05 - Notes & Revision History

REVISION HISTORY

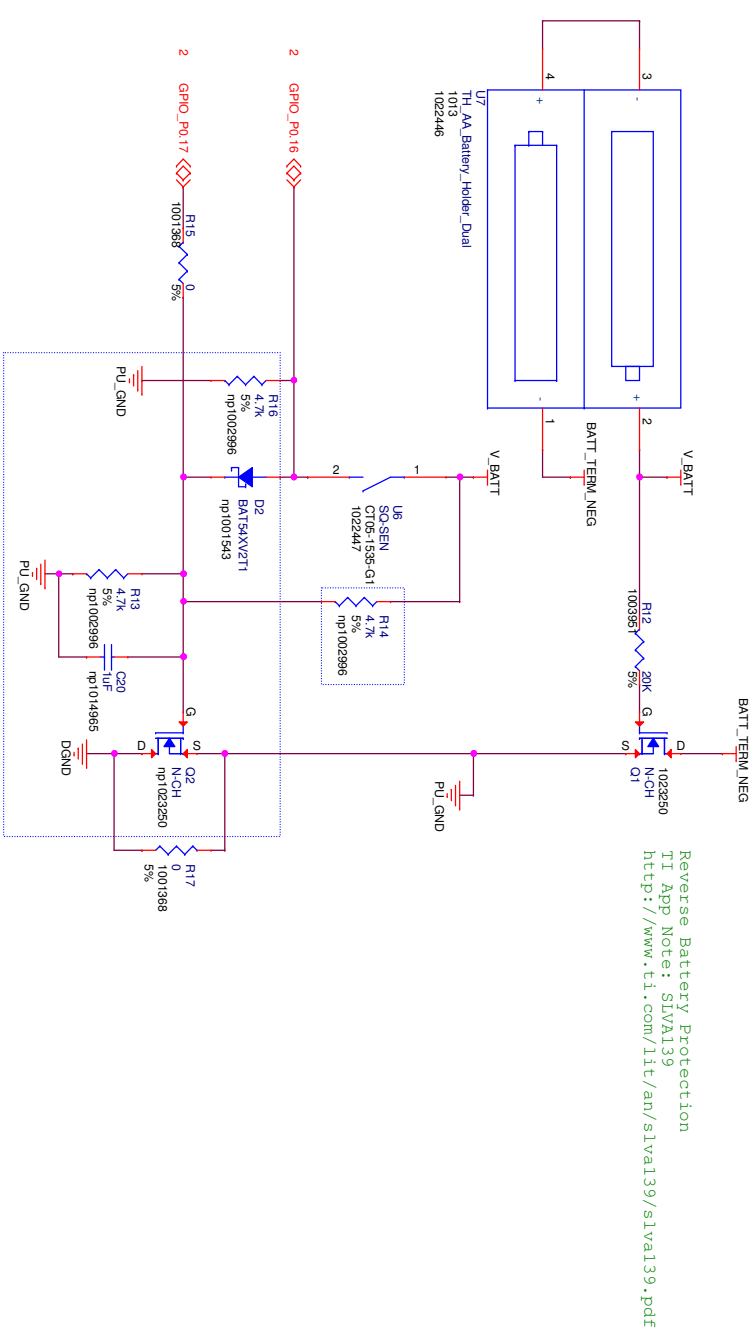
- Change C1 & C2 to 1009637 (16pF)
  - C3, C4 & Y2 moved to no populate part
  - Remove R1 & R2, replace with trace
  - Add mounting hole
  - Change Y2 to 1024409
- 03 - Sensors
- No Populated Temperature & Humidity Sensor: U4, R9, R10, C8
